**ADDENDUM NUMBER 01**

**LOTTERY HEADQUARTERS RENOVATIONS**

**DIVISION OF PUBLIC WORKS PROJECT NUMBER 81237R**

**March 22, 2024**

**E102**

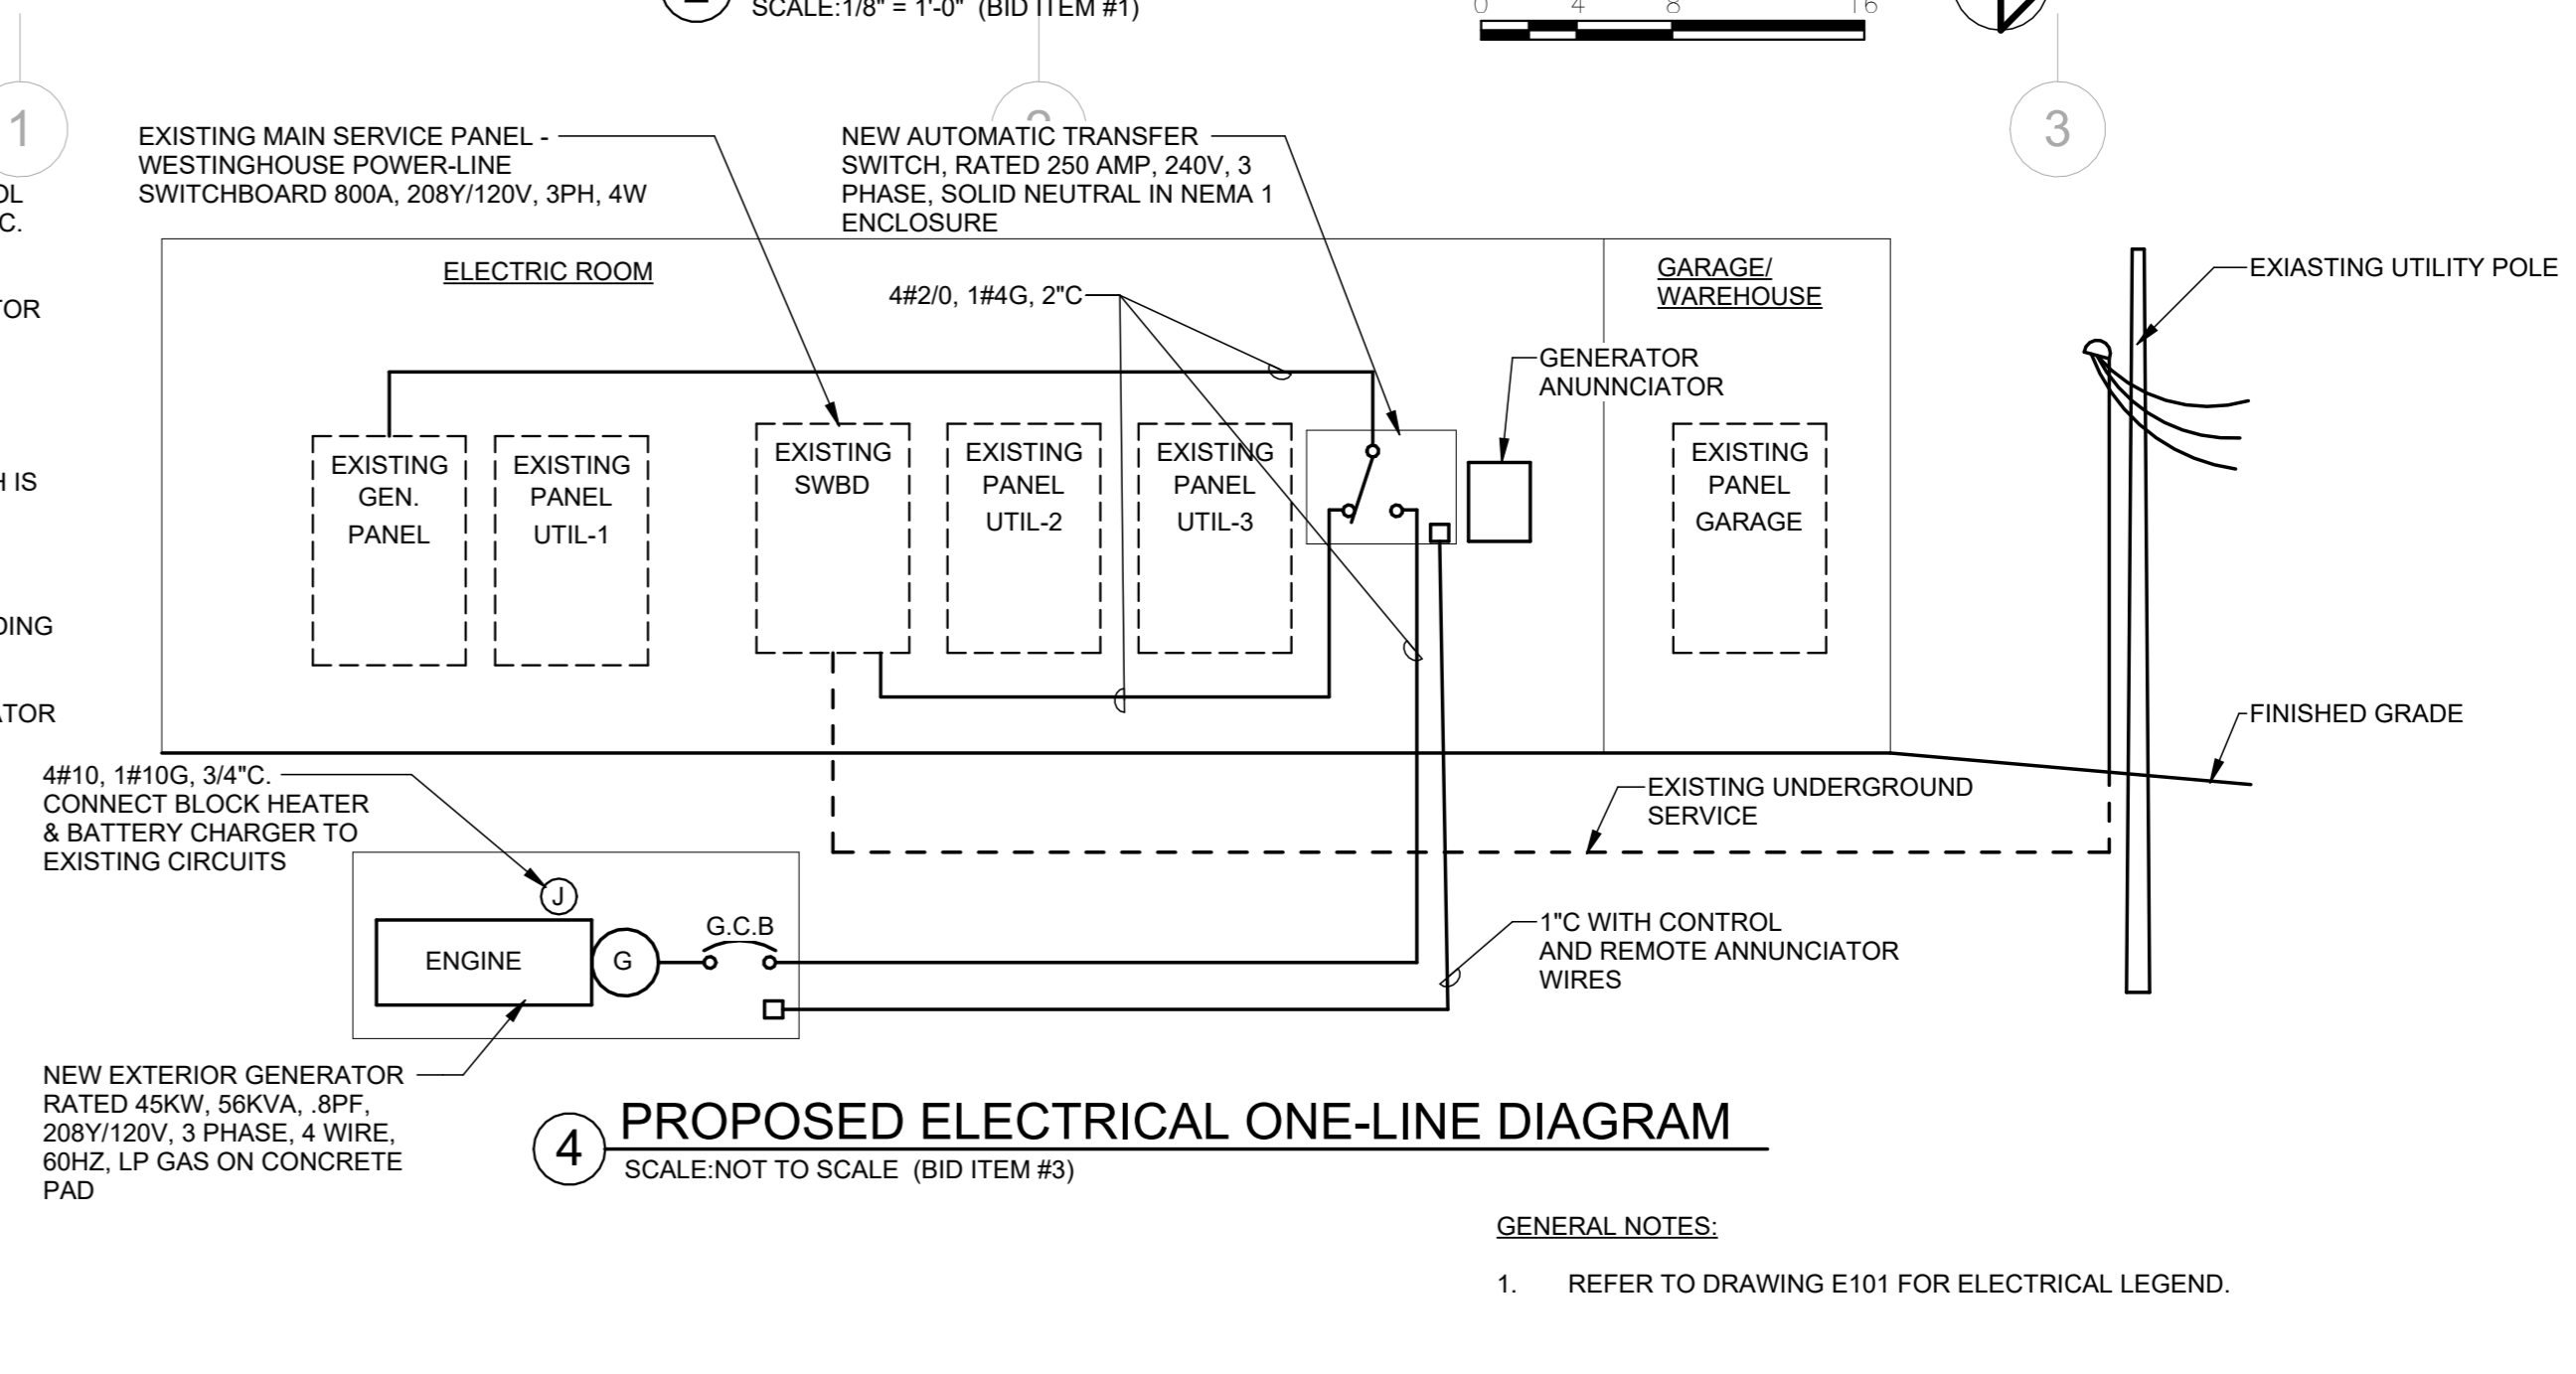
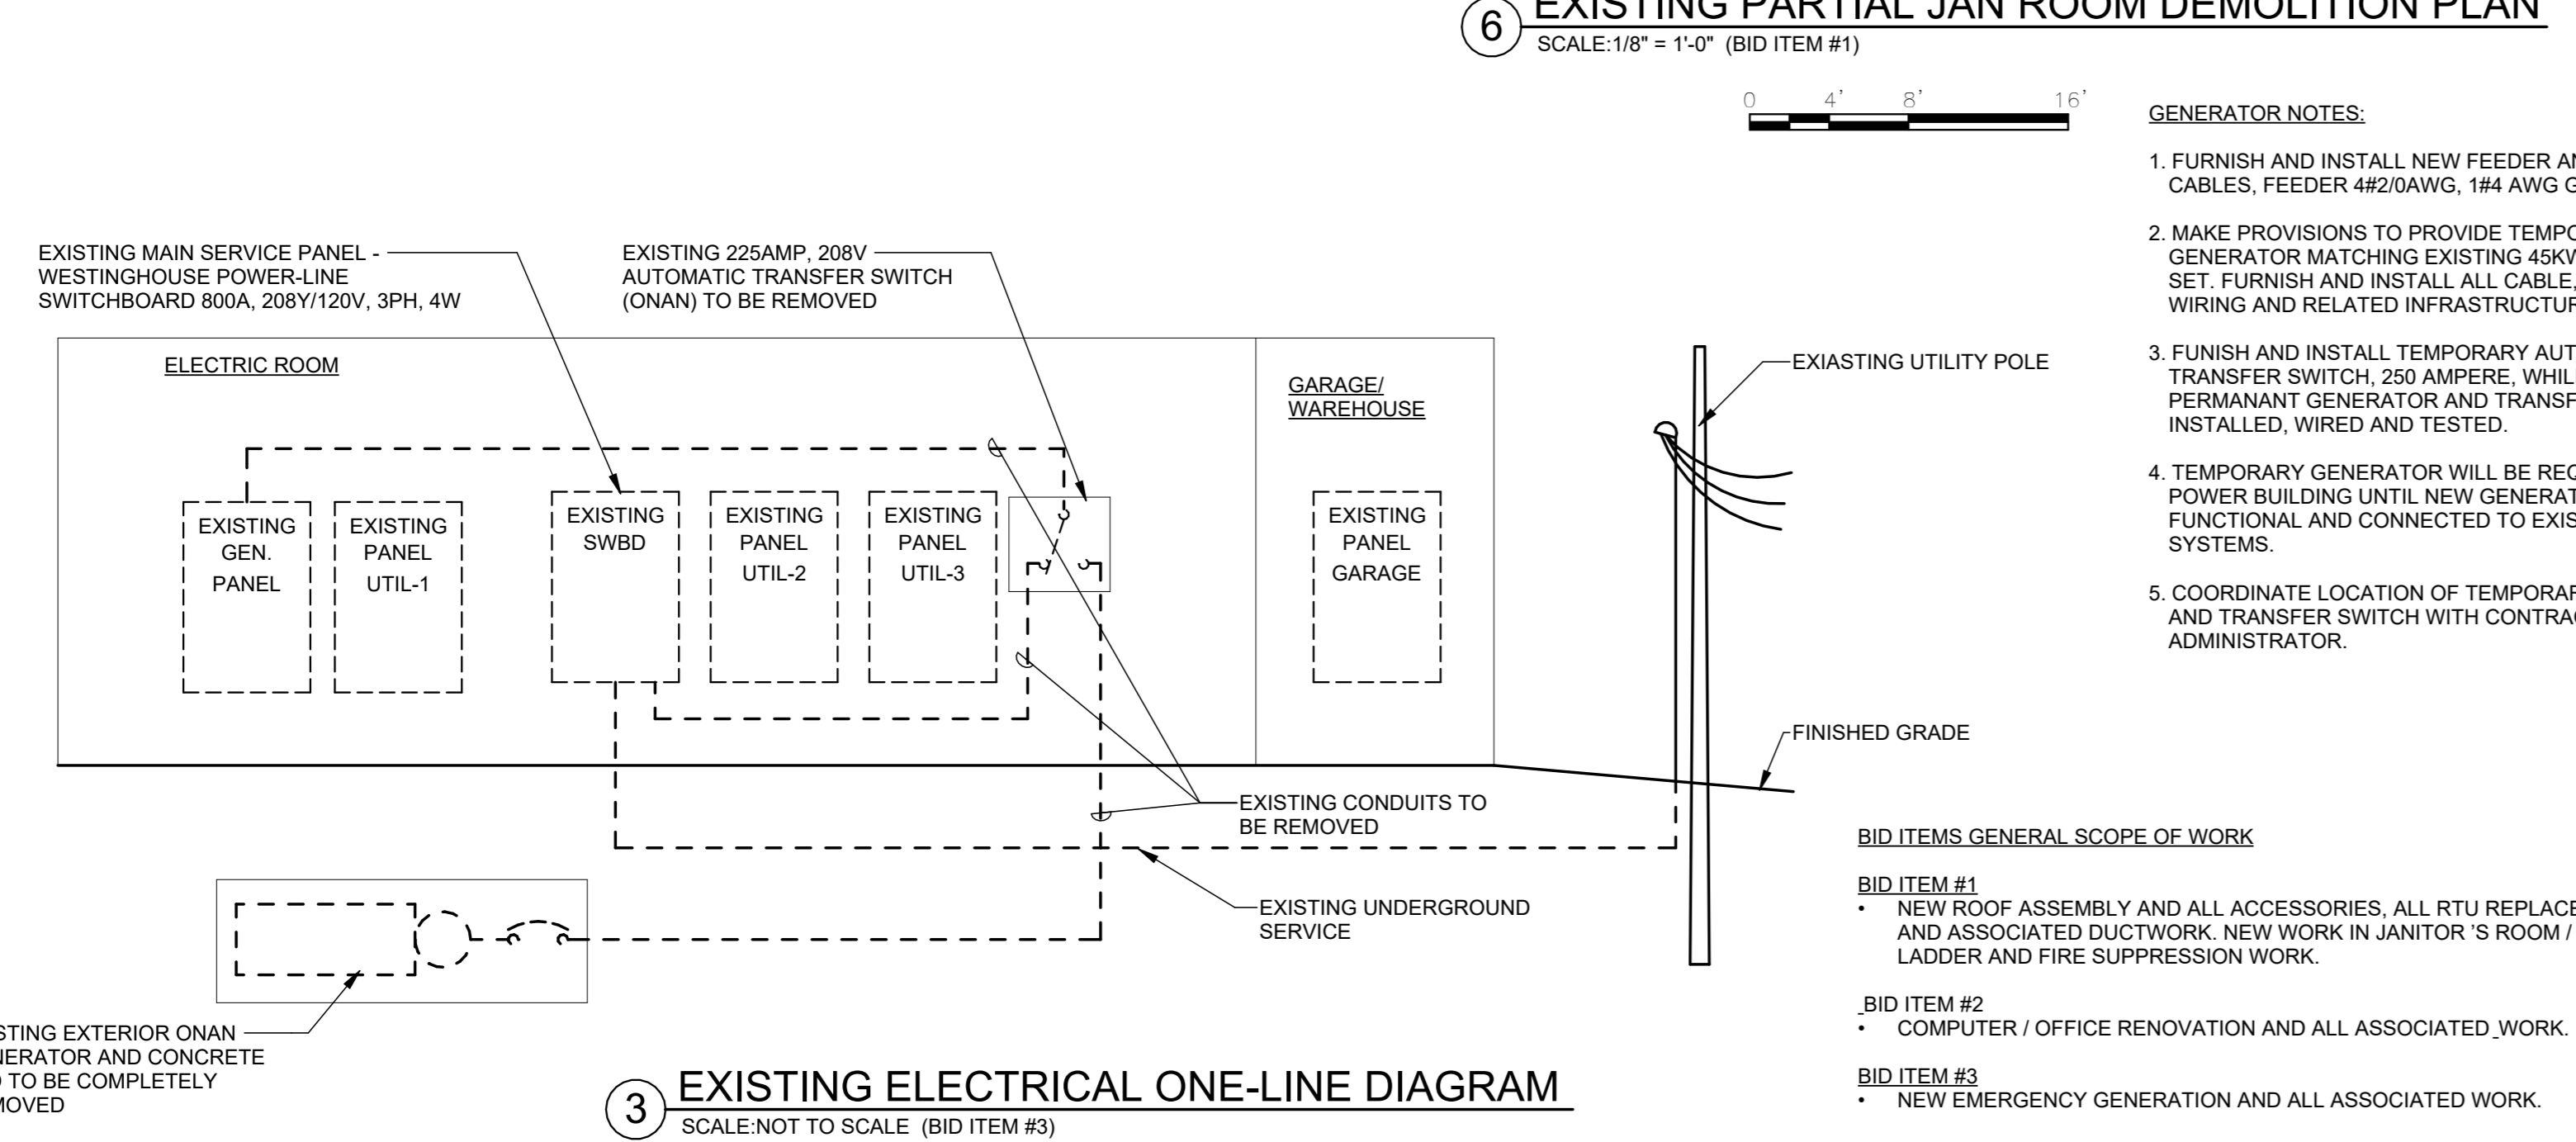
27. Question: Plan E101 shows the existing generator and existing underground exterior conduits being removed and disposed. New generator to be installed at adjacent location with new underground exterior conduits. Please confirm total interior concrete slab on grade square footage that will need to be sawcut – removed – patched in order to connect the new generator exterior conduits to the existing interior conduits.

28. Question: The provided “Information Report” sheet contains a line item #904 with the description “Provide and install new interior conduit for new emergency generator”. Please provide additional information on this scope: How much conduit will be required? What is the total lineal foot distance from the exterior wall to the final connection point, electrical room? Would this work be done during regular hours or off hours? Provide conduit material specification. Please confirm the new conduit will be installed overhead.

**Response:** *The intent is not to disturb the existing interior conduits under the concrete slab. If existing conduits are in usable condition and new wires can be pulled through them, they will be connected to the new generator through underground conduit on the exterior of the building.*

**Response:** *The intent of line item #904 is to provide a unit price to provide a conduit from the new generator to the electrical room should the existing conduit not be usable for the new conductors. The Bidder is responsible for visiting the site and verifying all dimensions, distances and quantities prior to submitting their bid. Provide and install new interior schedule 40 electric galv. conduit from new emergency generator entrance to new transfer switch within the electrical room. Provide (1) 2” dia. and (1) 1” dia. Vertical and horizontal run approx. 90 L.F., secure to structural frame as high as possible not to interfere with existing equipment. The work will be done during normal business hours with the least amount of disruption to the Owner’s use of the building. RGS conduit shall be used where subject to damage and on the exterior.*
